RPA STAFF RECOMMENDATION

Subdivision Case Number:	2016-060	PC Meeting Date: 11-14-16
Subdivision Name:	Skyfall Subdivision-PUD Lots 1 thru 35 and Community Lots C-1 thru C-08	
Applicant Request:	Final Plat	
Property Location:	Ooltewah Ringgold Road @ Quail Mountain Drive	
Property Owner:	Rick Harris	
Surveyor/Engineer:	Northpointe Surveying and Passpointe Engineering	
Total Acreage:	14.72 Acres	
Proposed Density:	2.17 dwelling units per acre	
Proposed Use:	Single-family detached dwellings	
Number of Lots:	32 Single-Family Detached Dwellings and 8 Community Lots	
Accessibility:	Extension of existing 50' Right-of-Way off of Ooltewah-Ringgold Road	
Tax Map Number:	160-037.04 and 037.05	
Zoning:	A-1 Agricultural District and R-2 Residential District a Planned Unit Development	
Subdivision Variances Required:	None	
Staff Recommendation:	<p>APPROVE as a Final Plat subject to the following conditions:</p> <ol style="list-style-type: none"> 1. Installation and completion of all required infrastructure related improvements as part of this subdivision development. 2. Submittal of all required infrastructure “as-builts” to the appropriate departments.

SKYFALL SUBDIVISION
 LOTS 1 - 35 AND CO

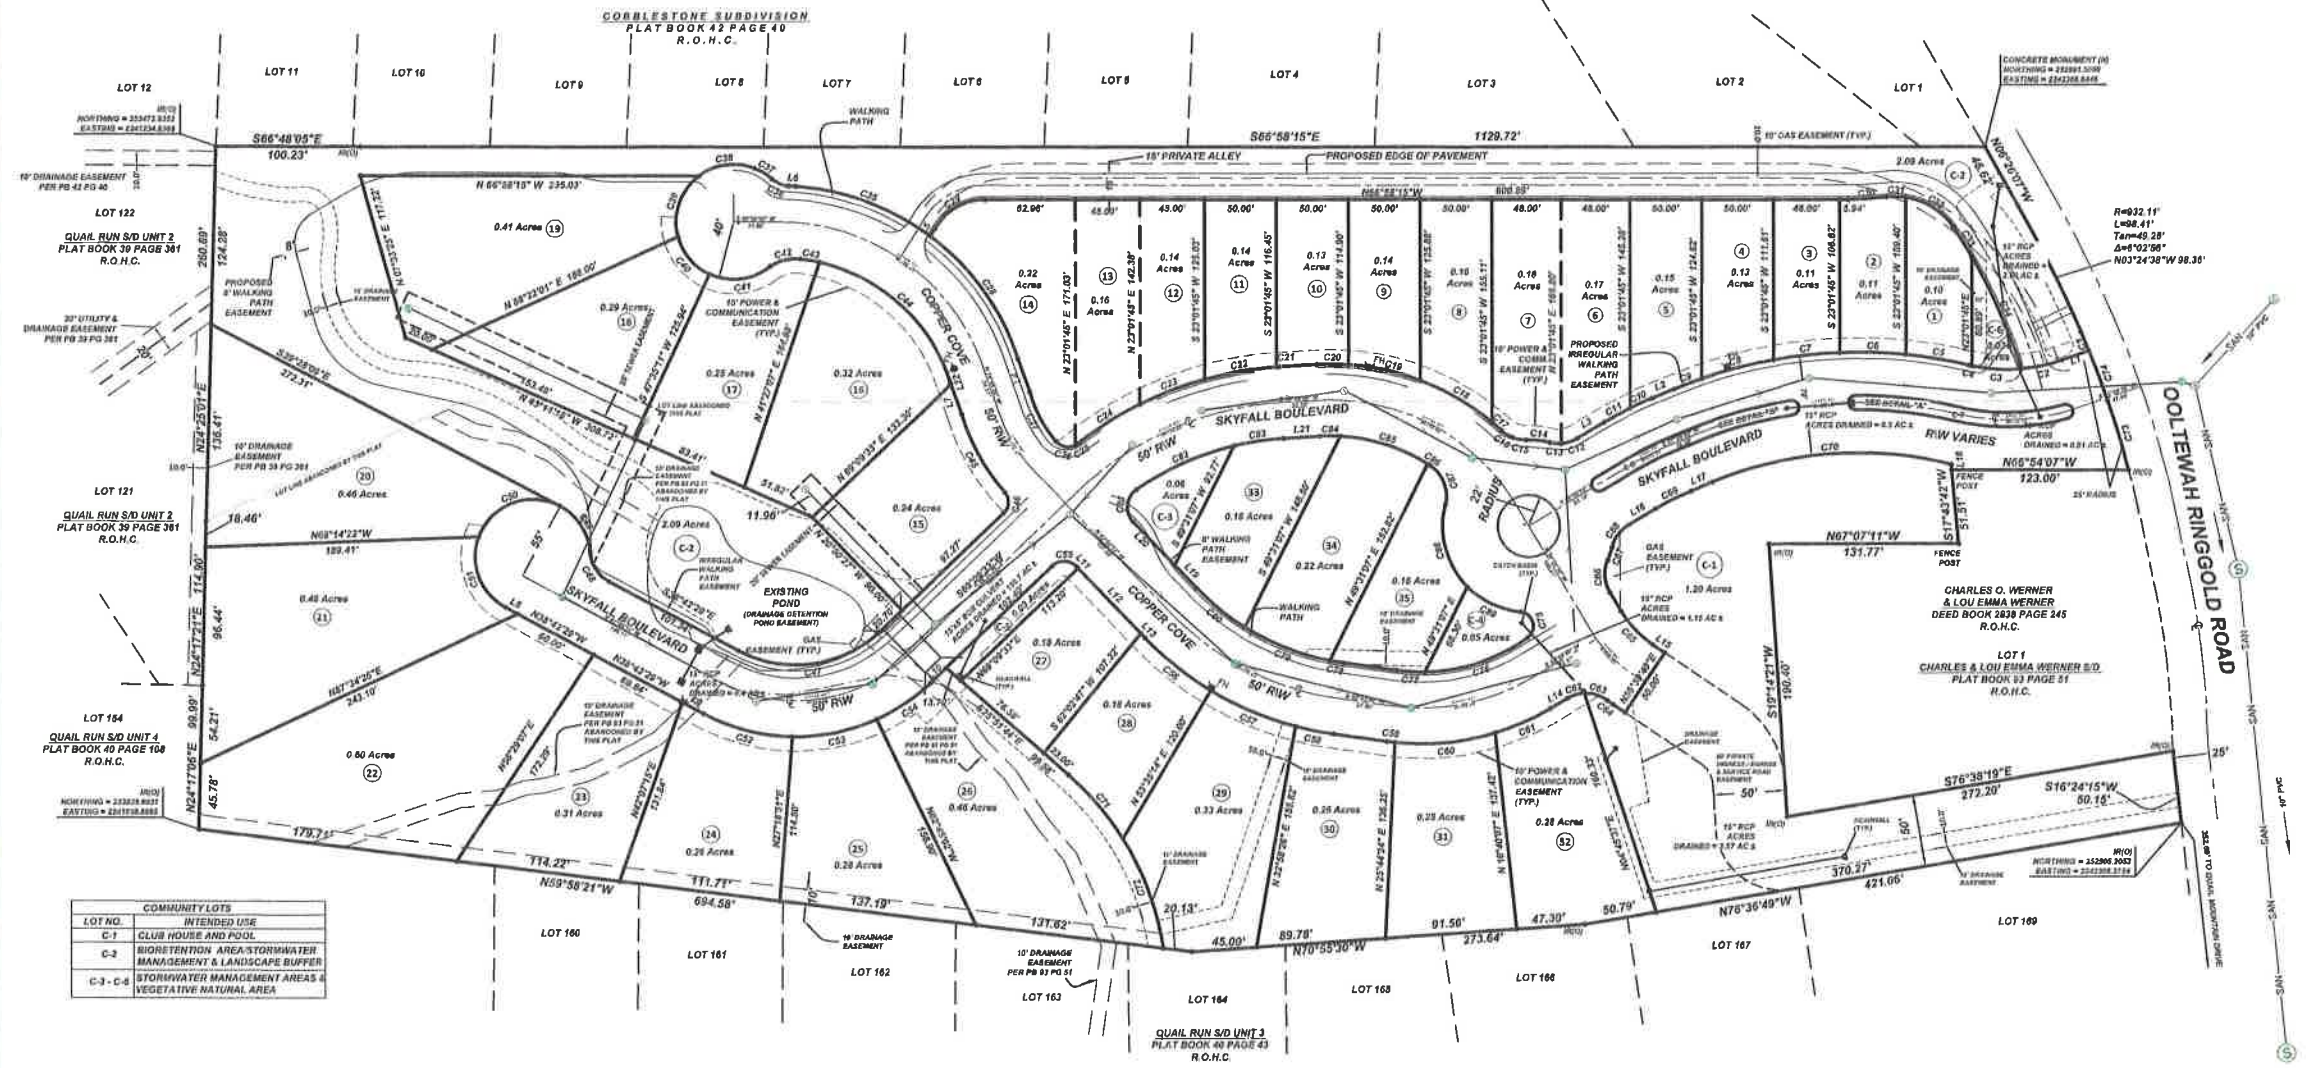
1. In proposed Lot 6 delete “proposed” from the irregular walking path easement.
2. Remove road profiles from the Final Plat. Road profiles are not required to be shown on the Final Plat.
